DRC-2020-013464

MEMORANDUM

SUBJECT: Review of the Energy Fuels Resources (USA) Inc. (EFR), White Mesa Uranium Mill, Blanding, Utah June 24, 2020 Source Assessment Report for Sulfate and TDS in Monitoring Well MW-31
Ground Water Discharge Permit No. UGW370004 (Permit)

Sulfate Data Plot of Historical Data at MW-31

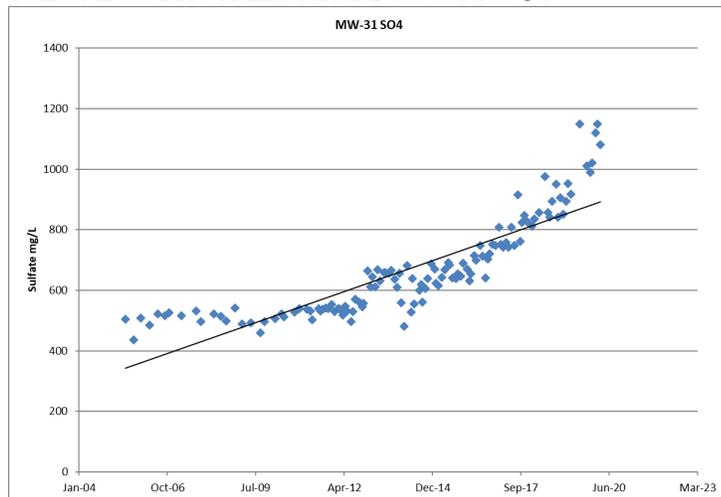
Sulfate – DWMRC notes that the Permit GWCL was modified/raised to 993 mg/L (from 697.6 mg/L) in the 2019 Permit modification. Sulfate concentrations in MW-31 are very low in comparison with other wells at the site. The highest historic value of sulfate is 1,150 mg/L (February 2020). This concentration is compared with highest historical values of other site monitoring wells (nearby MW-31) on the table below:

Per DWMRC review, the sulfate concentrations in MW-31 are low by comparison site wide. Sulfate concentrations are rising at several of the monitoring wells at the mill including upgradient and far downgradient monitoring wells.

Figure – TDS Data Plot of Historical Data at MW-31

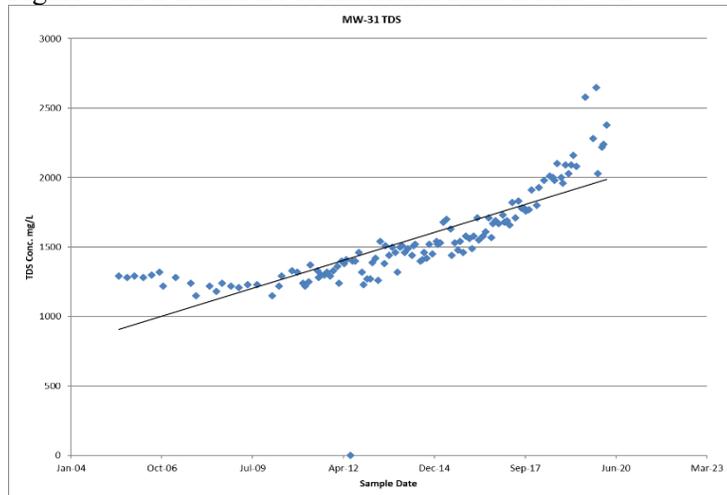
Total Dissolved Solids – DWMRC notes that the Permit GWCL was modified/raised to 2,132 mg/L (from 1,700 mg/L) in the 2019 Permit modification. TDS concentrations in MW-31 are low in comparison to site wide monitoring wells, including upgradient wells. TDS is largely affected by the nitrate/chloride plume, and, since the original concentrations are low, a systematic increase due to migration fluctuations in the plume create a relatively larger inflection (appears more considerable) than at other wells with higher existing background concentrations (less noticeable inflection) within the plume boundaries. MW-31 is also in proximity of the leading edge of the nitrate/chloride plume which results in a higher relative concentration curve than other wells which were central to the plume and show more stabilized concentrations or decreasing concentrations.

Figure – Fluoride Plot of Historical Data at MW-31 – Decreasing Trend

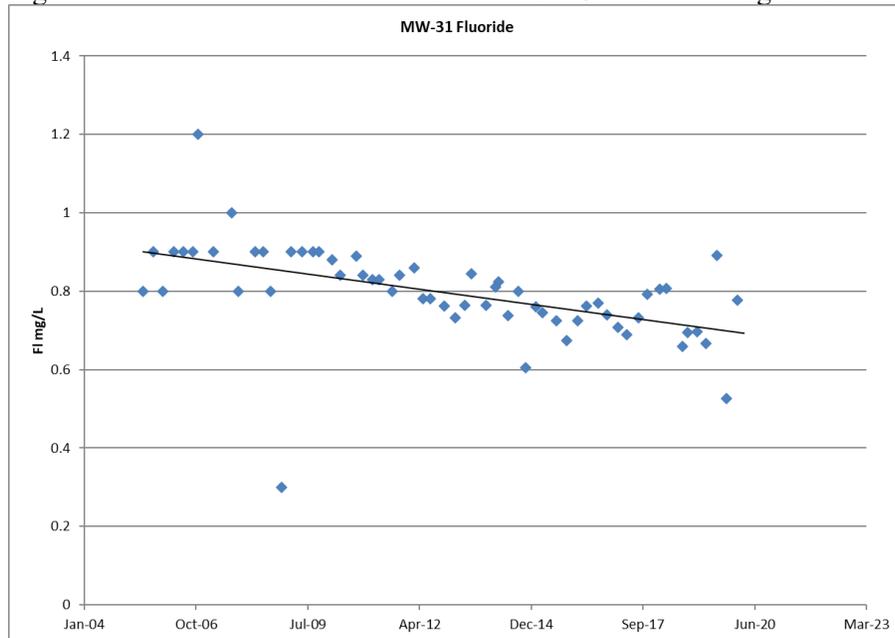
Fluoride is highly concentrated in tailings wastewater and per literature and mill groundwater transport modeling has been shown to be highly mobile in the vadose zone and groundwater beneath the tailings impoundments. Per the figure below, fluoride is showing a decreasing concentration trend in MW-31.

Mass balance calculations for fluoride have been reviewed by DWMRC. Per findings the concentration of fluoride in groundwater when compared with less mobile constituents in tailings wastewater are much lower; additionally as per the figure above overall concentrations are declining but would be increasing due to input of tailings wastewater which is high in fluoride concentration. Previous SAR’s used a comparison of selenium and fluoride in Cell 1 tailings wastewater and MW-31 groundwater and concluded that selenium is found at much higher percentages in groundwater than fluoride. Fluoride concentrations should be over 20 times higher to indicate a relationship with tailings wastewater.

Figure 5 – Concentrations of Atmospheric Tritium in the Southwestern United States

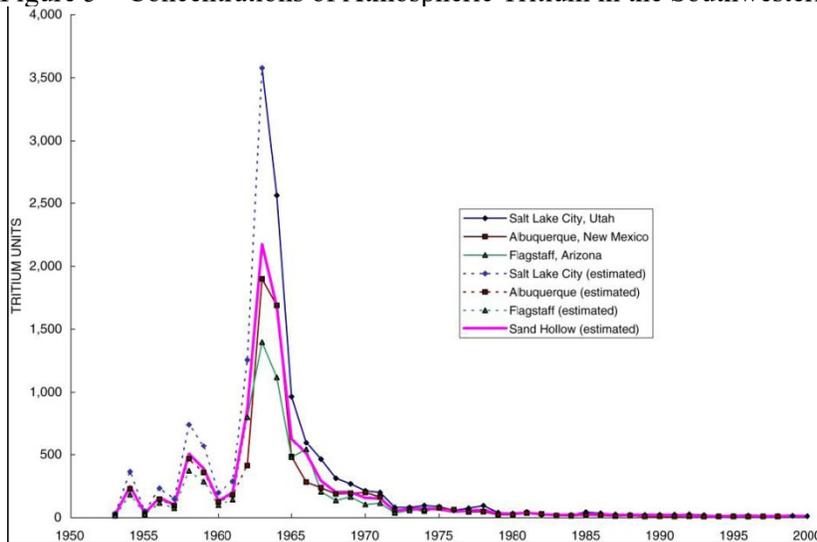
Additionally, tritium concentrations in monitoring well MW-31 were found to be non-detect. If ground water in monitoring well MW-31 had a surface infiltration source post 1950’s (time period of atmospheric injection of tritium during above-ground thermonuclear weapons testing) then tritium concentrations would be expected in ground water samples in monitoring well MW-31. Figure 5 below is taken from the University of Utah (“U of U”) Report (Hurst and Solomon 2008) and depicts atmospheric concentrations of tritium in the southwest by year.

Based on review of the U of U Report and specific data results for monitoring well MW-31 age dating of groundwater at the well indicates that the MW-31 groundwater predates Mill construction.
